Manitoba Clean Environment Commission
Hearing for the Vivian Silica Sand Extraction Project (Project)
Sio Silica Corporation (SSC) Responses to Information Requests (IRs) Round No. 2

IR Number: DLN-IR-001

Submitted by: DLN

Subject Matter: Air injection

Figure 2. Air entrained in by the overflow v notch weir and the receiving pool of a clarifier tank⁷

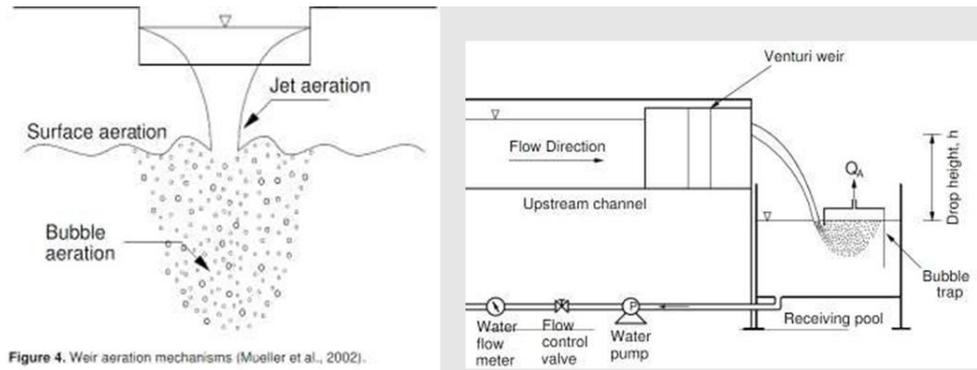
Entrained air in the process wastewater as documented in DLN IR 002 is major issue overlooked by Sio Silica. Further evidence of air entrainment in a clarifier by the V notch overflow weir of the clarifier and in effluent water plunging into a process water receiving tank is illustrated in figure 2.^{7,8}

27. The water in the frac tanks will contain large amounts of entrained gaseous air as illustrated by the aerated water jet filling the frac tanks show in figure 1. The water plunging into the tank would entrain more air.⁶ Bubbles of entrained gaseous air when injected into the aquifer at year end would rise, enter the carbonate aquifer through the degraded shale, spread rapidly through the water bearing fractures of the carbonate aquifer causing precipitation iron and manganese and fostering the proliferation of well- fouling iron bacteria. The degradation of the shale aquitard is modelled in the Hydrogeological Report. The precipitation of iron and manganese due to oxidizing conditions and the proliferation of iron from the aerated water is documented in the public comments for the Extraction EAP by Dr. E. Pip. Please clarify why this re-injection of vessel and slurry line water at Project year end would not contradict the statement in response (h), *"Sio similarly does not expect any adverse impacts on local water supplies from extraction activities."*

28. The entrained air in the process water would be in all the water re-injected into the sandstone aquifer throughout the extraction process, not just at year end. Air would be entrained in the clarifier tanks and hydrocyclones used for the UV filtration systems. For example air would be entrained in plunging water from the v notch overflow weir in the clarifier and in the plunging water entering the collection tank for the wastes water from the clarifier as illustrated in Figure 2.^{7,8} Hydrocyclones have an air core as illustrated and documented in DLN IR 002 that would entrain gaseous air. Please clarify why the adverse impacts of re-injection of water containing entrained gaseous air described in request for clarification 16, that would occur throughout the Project year, would not contradict the statement in response (h), *"Sio similarly does not expect any adverse impacts on local water supplies from extraction activities"*

27. The Groundwater Monitoring and Mitigation Plan will monitor groundwater in the formation and prior to re-injection for a suite of parameters to confirm the extraction process is performing as expected. The system will be designed to minimize the possibility for proliferation of bacteria. The supply of oxygen to the aquifer will not be unlimited and will therefore not allow for complete oxidation of any reduced form minerals.

28. The Groundwater Monitoring and Mitigation Plan will monitor groundwater in the formation and prior to re-injection for a suite of parameters to confirm the extraction process is performing as expected. The system will be designed to minimize the possibility for proliferation of bacteria. The supply of oxygen to the aquifer will not be unlimited and will therefore not allow for complete oxidation of any reduced form minerals.
